**Agri-Mark, Inc. d.b.a. Cabot Creamery
Polished Permeate Spray Disposal System
2018 Annual Inspection Report
Indirect Discharge Permit # 9-0043**

Re: Agri-Mark, Inc. d.b.a. Cabot Creamery, Indirect Discharge Permit # 9-0043
2018 Annual Inspection of Spray System
JCO # 1-0303-1

FIGURE 1

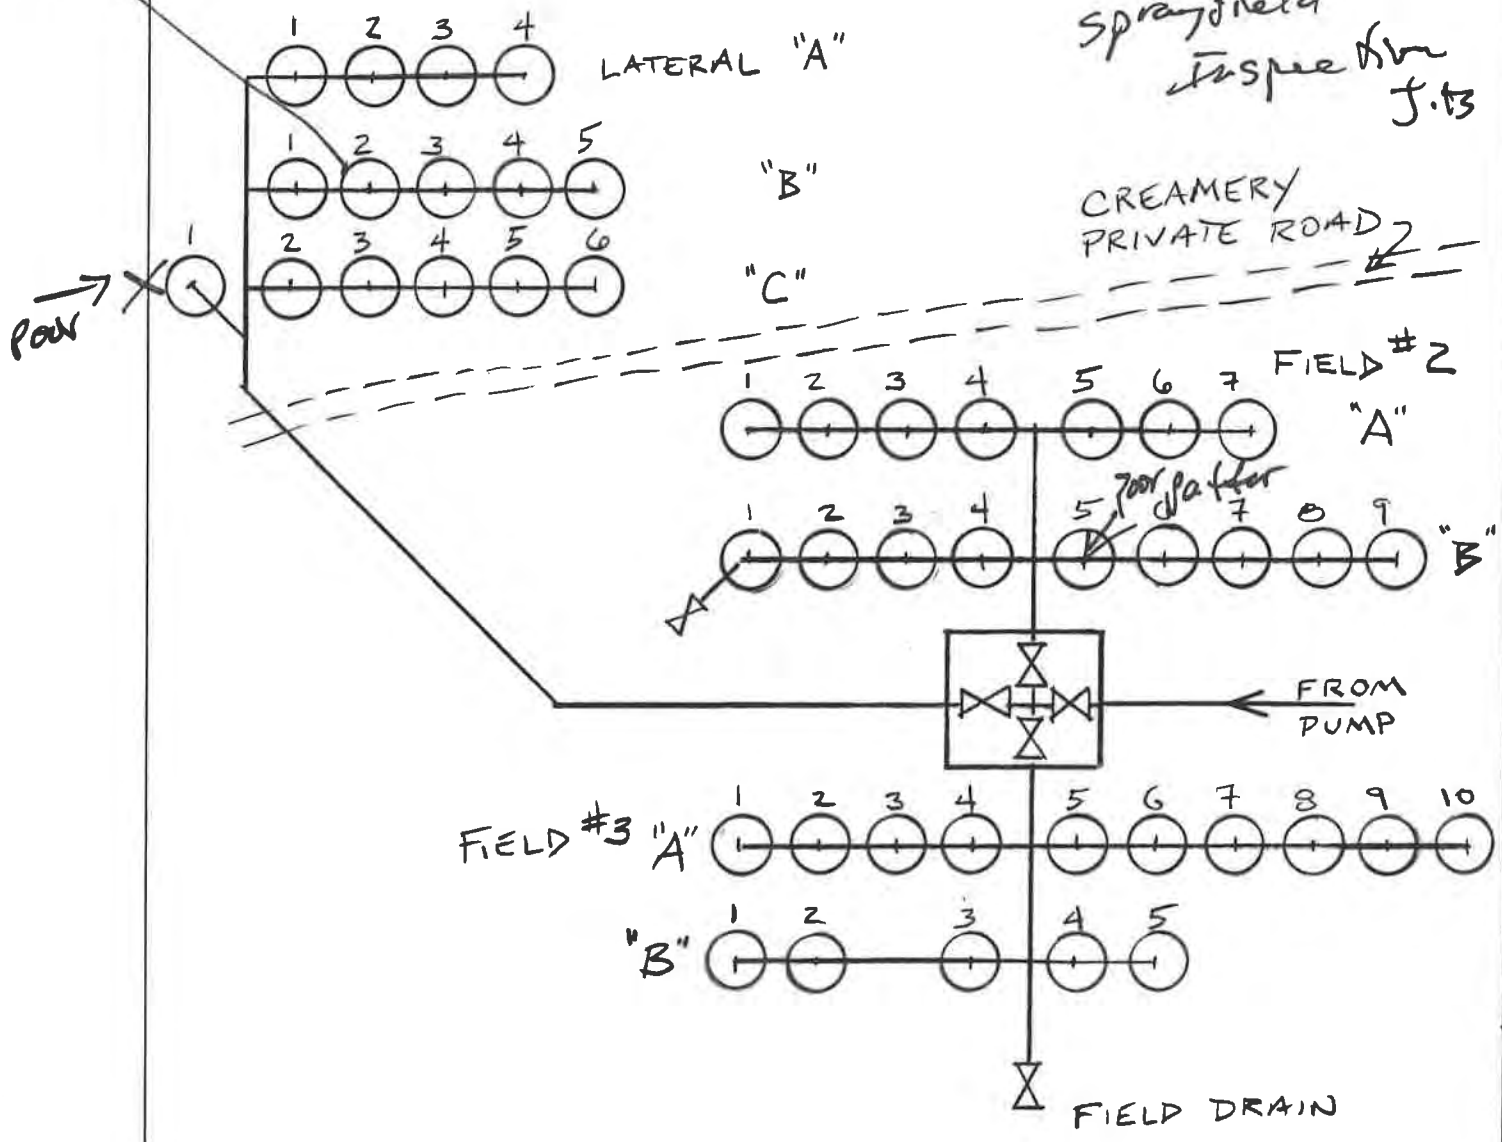
The spray disposal system was operated to inspect the spray heads. During the inspection it was observed that all sprinkler heads were in place (except for one in Field #1 B2) and all were operating properly with the exception of two sprinkler heads with poor spray patterns (Field #1 C1 and Field #2 B5 on attached Figure 1).

Leaky
Missing
Head

1. Continue mowing and brush cutting activities on the storage lagoons. Inspect and monitor the force main drain headwall for movement. Replace the sod and restore the southwest corner of the embankment at Lagoon #3
2. Continue to maintain an operation log book for the spray irrigation pump system.
3. Install, replace or clean spray heads as needed for proper operation. Periodically observe the spray heads in operation and clean those noted to be improperly functioning.
4. Continue to cut back brush and trim trees around the spray fields.
5. Annually exercise the valves in spray field valve pit.
6. Fix the leak at the spray system drain at Lagoon #3.
7. Replace or repair the cover for the spray field valve pit.
